SERVICE BULLETIN REVISION TRANSMITTAL SHEET

Service Bulletin No. 604-32-033

Revision No. 01 Dated Nov 04/2025

MODIFICATION – NOSEWHEEL STEERING – REPLACEMENT OF POTENTIOMETER UNIVERSAL COUPLING (T16-6) SETSCREWS

Replacement of Universal Coupling (T16-6) Setscrews
Figure 1

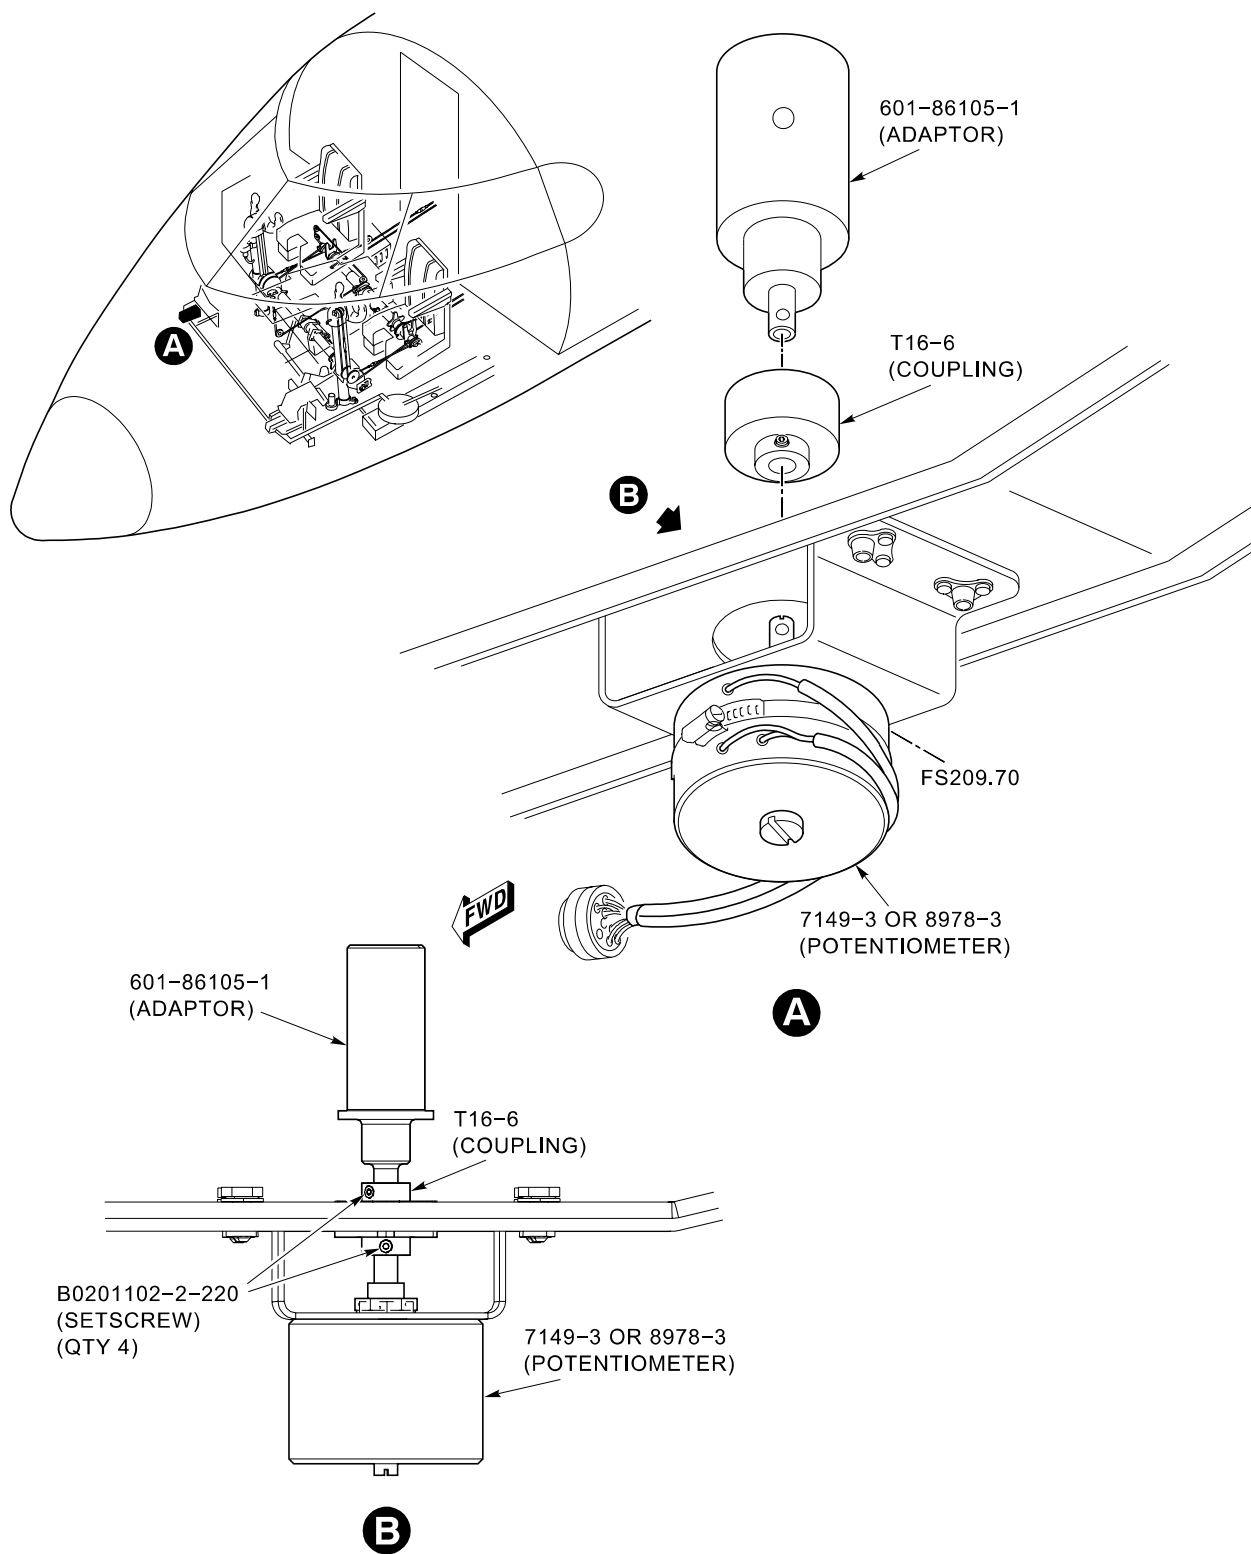
Due to rudder pedal potentiometer universal coupling setscrews possibly having inadequate torque and the use of non self-locking setscrews.

There is one report of uncommanded steering resulting in lateral runway excursion due to the rudder pedal potentiometer universal coupling not properly clamping the potentiometer shaft. This resulted in the pedals moving the potentiometer in one direction only (ratcheting). Due to normal repeated usage at landing, the potentiometer was not following pedal command.

The Service Bulletin instructs to replace the T16-6 coupling and its setscrews, application of anaerobic retaining compound and rigging of nosewheel steering alignment if required.

- (1) Get access to potentiometer universal coupling, Part No. T16-6 on rudder feel unit assembly.
- (2) Replace the rudder potentiometer universal coupling as follows:

- (a) Remove the potentiometer and coupling per AMM 32-51-04-000-801 in accordance with AMM Rev 104 and subs, per the applicable procedure (Pre SB 604-32-033).

- (b) Install the new coupling and potentiometer per AMM 32-51-04-400-801 in accordance with AMM Rev 104 and subs, including the task instructions related to Post SB 604-32-033 (using new coupler, new type self-locking setscrews, anaerobic retaining compound and specified torque).

- (c) Rig the potentiometer per AMM 32-51-04-820-801 in accordance with AMM Rev 104 and subs, following task instructions related to Post SB 604-32-033.

NEW PART NO.	QTY	ITEM	USED PART NO.	INSTRUCTIONS - DISPOSITION
B0201102-2-220	8	Self-locking Setscrew	MS18063-2	Discard
